**GREENWAY IMPROVEMENT DISTRICT  
BOARD OF SUPERVISORS' MEETING MINUTES**

RE: Construction Contract Status

**ROOT CAUSE ASSESSMENT & RECOMMENDED REMEDIAL MEASURES**  
**SOIL UNDERMINING & ENTRY INTO BARRELS OF RCP CULVERT CROSSING (4@36")**  
Nemours Parkway Phase 6  
Lake Nona South, City of Orlando, Florida

Change Order No. 004

Exhibit 5.1 Root cause explanation of soil loss

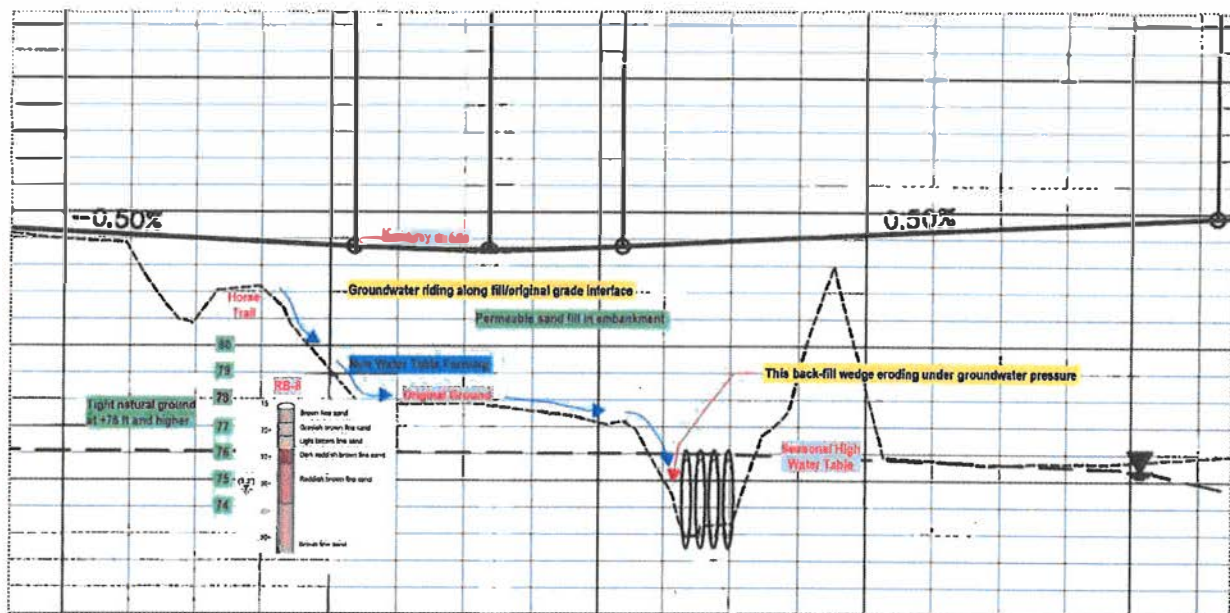
Exhibit 5.1 provides an illustration of the root cause explanation of the soil loss of the wedge of the soil and the sand accumulation in the channel. The sand is being eroded and undermined with seepage combined with some toe undercutting on the south side of the Quad 36 when the flow direction in the channel is south to north.

The sand bulging into the channel on the north side is due to a natural instability as this is the focal point of discharge for the subregional groundwater flow into the "goose neck" of this wetland slough. The soil loss on the south side of the Quad 36 is due in part to toe undercutting from the northward flow in the channel but primarily due to the high water table pressure pushing out the fill dirt above and adjacent to the pipe. Note that the natural soil on the south side is stable but the fill material adjacent to the pipe is being eroded.

A new water table will form at the contact of the fill and the original sloping ground and this subterranean water will move to the culvert, where it will be impeded by the pipe side wall and from there migrate to discharge at the culvert openings. The basin for this perched water table under the fill will start at least at the horse trail and move toward the Quad 36 as shown in Exhibit 5.1.

The retrofit will have to achieve the objective of armoring the slopes around the culvert mitered ends with a weighted permeable system (such as rip rap or articulating concrete blocks) on a filter fabric to prevent loss of the fine sand backfill from the embankment into the channel. Similar armoring over filter fabric is required on the channel bed at the north and south end treatments, and also extending up the sides and above the top of the mitered end concrete slab.

FDOT quality rip rap is required at all coverage areas on the channel bed and extending up the slope to 2 ft above the 100 yr flood stage. This higher grade rip rap is recommended since the surface water in the channel is within a wetland system which is typically acidic and tends to disintegrate limestone or broken concrete over time. Lower quality rip-rap may be used 2 ft above the flood elevation if there is a significant cost savings to the CDD and if the aesthetic change in rip-rap appearance is acceptable to the CDD.

The thickness of the channel bed and slope armoring rip rap should be at least 12 inches. The filter fabric under the rip rap shall comply with FDOT specifications for similar applications.

# NEMOURS PARKWAY PHASE 6 SCOUR PROTECTION

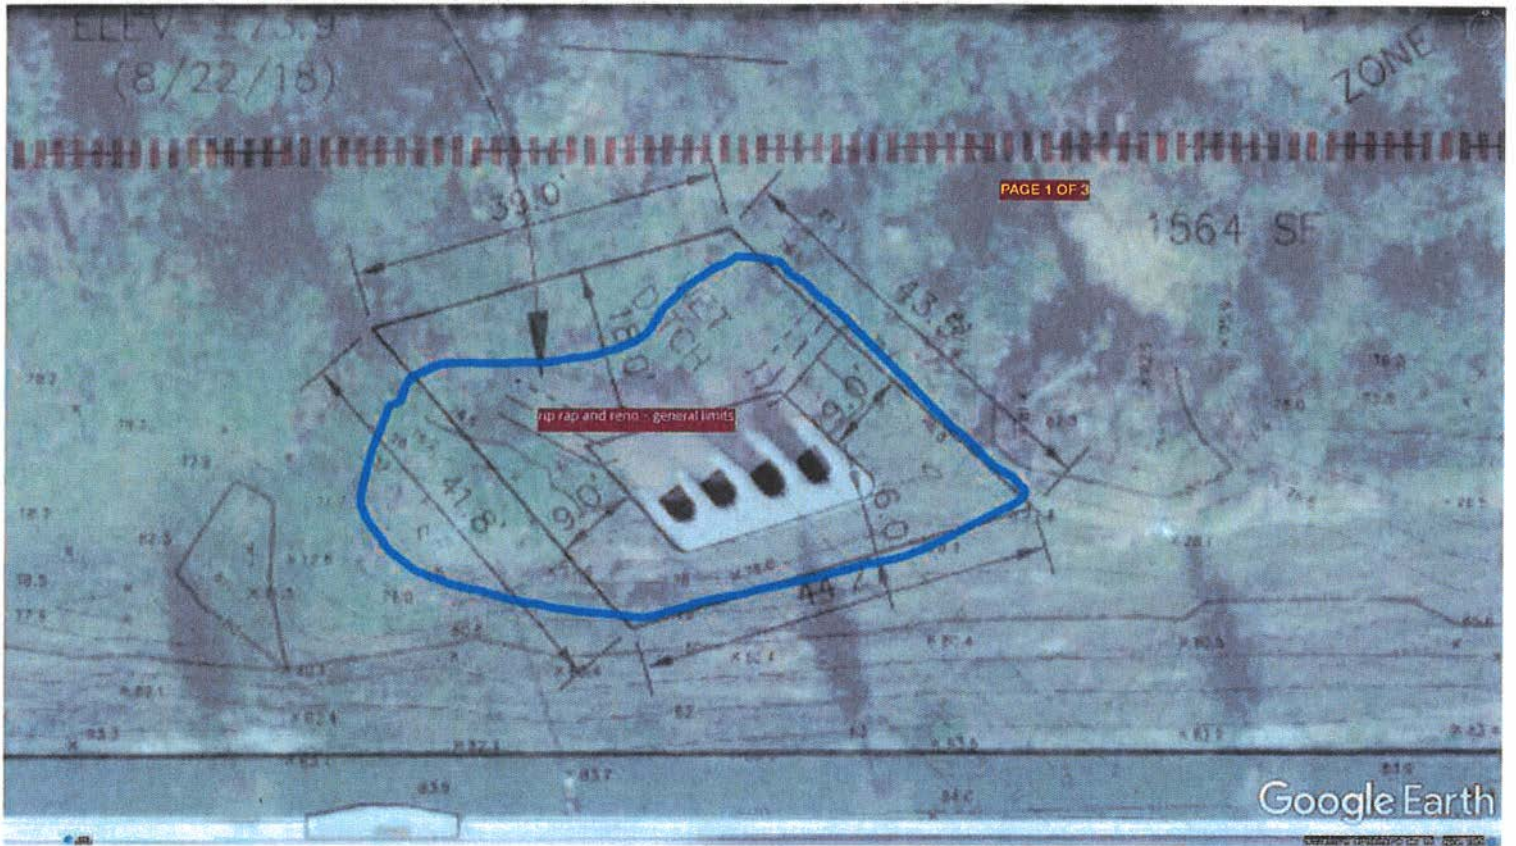
THIS PROPOSAL IS INCLUSIVE OF THE ADDED SCOUR PROTECTION REMEDIATION PER THE PLAN  
REVISION/ SKETCH RECEIVED ON 5/16/19

ITEM NO.	WORK PERFORMED	DESCRIPTION OF CHANGE	AMOUNT + / (-)
1	Erosion Repair and Expanded Protection at the North and South Ends of the Qual 36" Culverts	ADD	\$77,713.83

# NEMOURS PH. 7 - ADDED HOSPITAL LATERALS

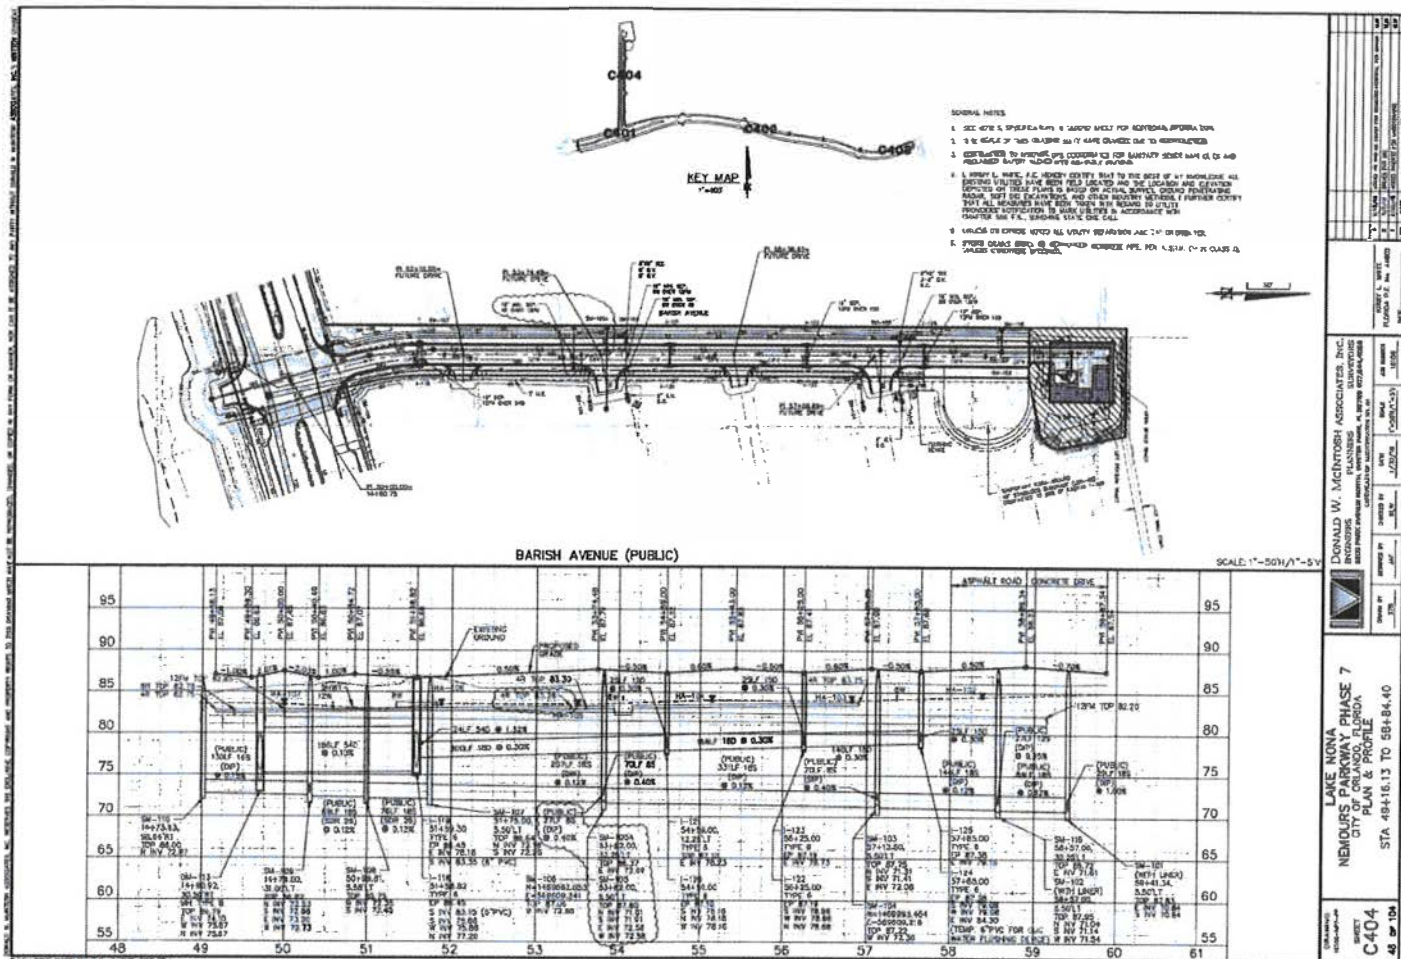
THIS PROPOSAL IS INCLUSIVE OF THE ADDED SANITARY AND RECLAIM SERVICE LATERALS INTENDED TO SERVE THE NEMOURS CHILDREN'S HOSPITAL. ALL OTHER CHANGES NOT SPECIFIED BY THIS PROPOSAL ARE TO BE CONSIDERED NOT INCLUDED.

ITEM NO.	WORK PERFORMED	DESCRIPTION OF CHANGE	AMOUNT + / (-)
1	Add Sanitary and Reclaim Service Laterals Intended to Serve the Nemours Children's Hospital	ADD	\$ 12,879.00
